STAFF REPORT

SUBJECT: SWIG – CUP
[H-2023-0014](#)

LOCATION: 3471 W. Chinden Blvd. in the NE 1/4 of Section 27, T.4N., R.1W. (Lot 2, Block 1, Lost Rapids West Subdivision)

Conditional Use Permit (CUP) for a drive-through establishment within 300-feet of another drive-through facility, a residential district and existing residences on 0.59-acre in the C-G zoning district.

A. Proposed Site Plan

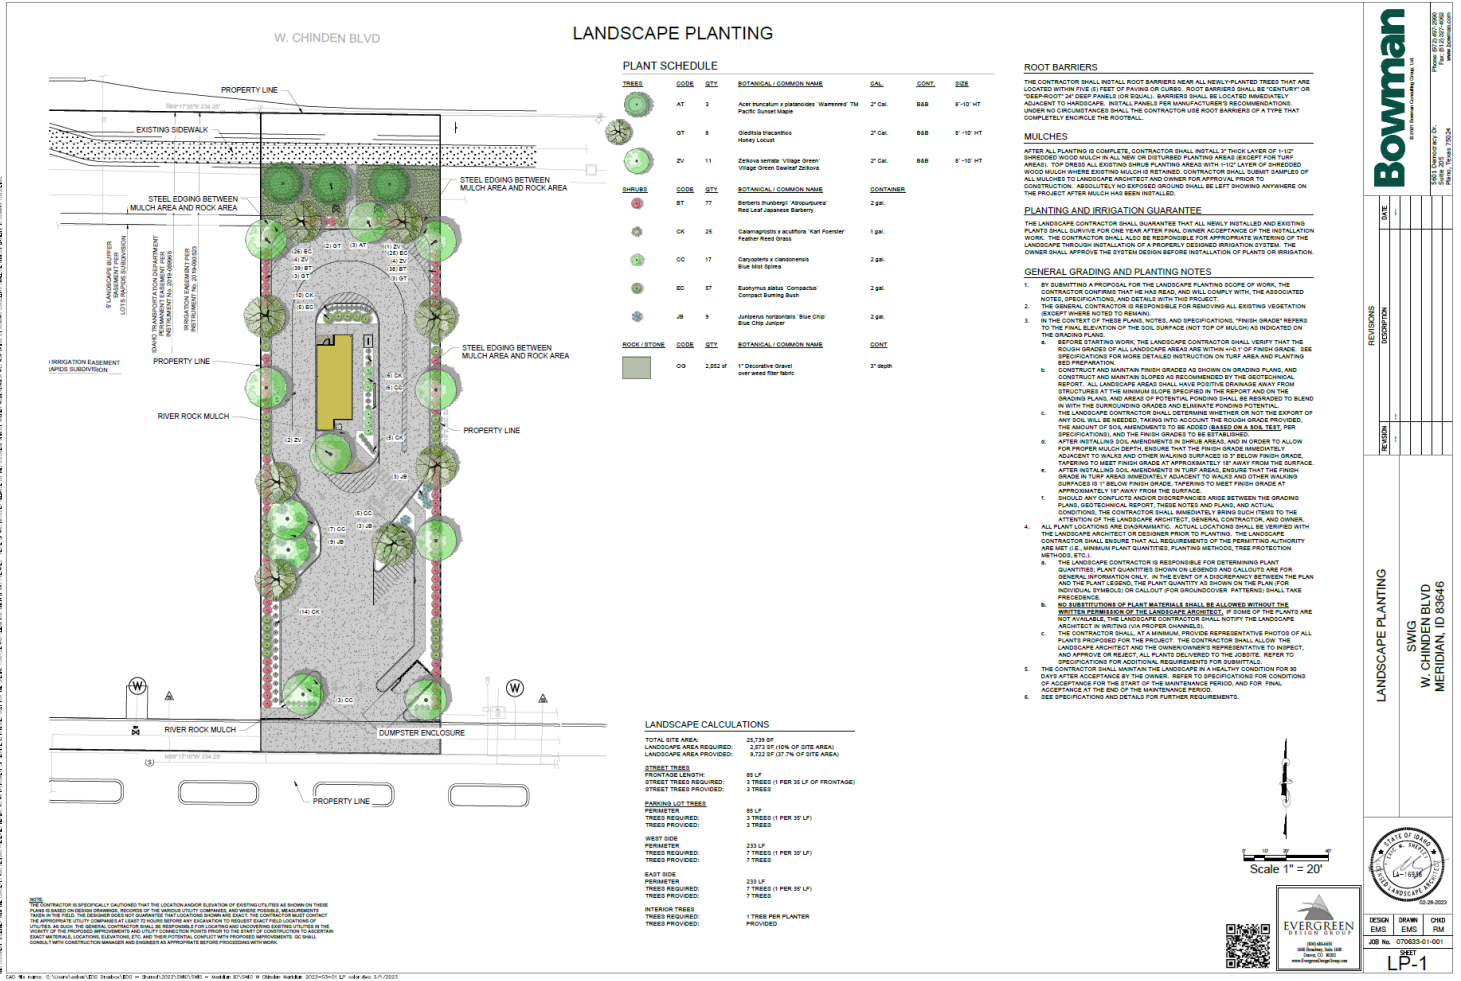
- Drive-Through Establishment:** The proposed drive-through establishment is subject to the specific use standards listed in UDC [11-4-3-11](#), Drive-Through Establishment. All establishments providing drive-through service are required to identify the stacking lane, menu and speaker location (if applicable), and window location on the site plan. *Menu boards are proposed as depicted on the site plan in each of the drive-through lanes; speakers are not proposed as SWIG staff walks up to the customers to accept orders prior to the drivers going to the pick-up window. The pick-up window is depicted on the site plan and elevations at the southwest corner of the building on the west side. In order for the outside travel lane to function as an escape lane as required for drive-throughs that exceed 100-feet in length, Staff recommends no stacking is allowed in this area and the menu board is removed. Signage should be installed notifying patrons not to block the escape lane.*

The design of the site requires traffic to pass through the escape lane for the drive-through to exit the site. The escape lane (outside travel lane) should remain open with no stacking allowed in order for the circulation lane to remain open.

The stacking lane is approximately 180+/- feet from the point of entry to the drive-through window; therefore, the stacking lane exceeds 100' in length and an escape lane is required. An escape lane is depicted on the site plan.

The drive-through is located on the west side of the building and is visible from W. Chinden Blvd. and from the drive aisle along the southern boundary of the site for surveillance purposes.

A bicycle rack capable of holding at least one (1) bicycle is required per UDC [11-3C-6G](#); bicycle parking facilities are required to comply with the location and design standards listed in UDC [11-3C-5C](#). A bike rack is depicted on the site plan; **a detail should be included on the site plan submitted with the Certificate of Zoning Compliance application that complies with the aforementioned**

Sidewalks: A 10-foot wide sidewalk/multi-use pathway exists within the street buffer along W. Chinden Blvd. A pedestrian walkway is proposed from the sidewalk along Chinden and from the sidewalk along the southern boundary of the site to the main building entrance, as required by UDC 11-3A-19.B.4. **Where pathways cross vehicular driving surfaces, they're required to be distinguished from the vehicular driving surface through the use of pavers, colored or scored concrete, or bricks as set forth in UDC 11-3A-19B.4. The site/landscape plan submitted with the Certificate of Zoning Compliance application should reflect compliance with this standard.**

2. The site plan and landscape plan submitted with the Certificate of Zoning Compliance application shall be revised as follows:
 - a. All mechanical equipment on the back of the building and outdoor service and equipment areas should be incorporated into the overall design of buildings and landscaping so that the visual and acoustic impacts of these functions are fully contained and out of view from adjacent properties and public streets as set forth in UDC [11-3A-12](#).

- b. The pathways from the perimeter sidewalks to the main building entrance shall be distinguished from the vehicular driving surface through the use of pavers, colored or scored concrete, or bricks as set forth in UDC 11-3A-19B.4b.

- c. Include the tree classification in the Plant Schedule that demonstrates compliance with the standards in UDC [11-3B-8C.1b](#).
 - d. Include a detail for the bicycle rack that complies with the design standards listed in UDC [11-3C-5C](#).

- e. No stacking is allowed in the outside travel lane that serves as an escape lane; depict signage notifying patrons not to block the escape lane. Remove the menu board from the outside travel lane.

- f. Signage should be installed notifying patrons walk-up ordering is not allowed.
3. Compliance with the standards listed in UDC [11-4-3-11](#) – Drive-Through Establishment and [11-4-3-49](#) – Restaurant is required.
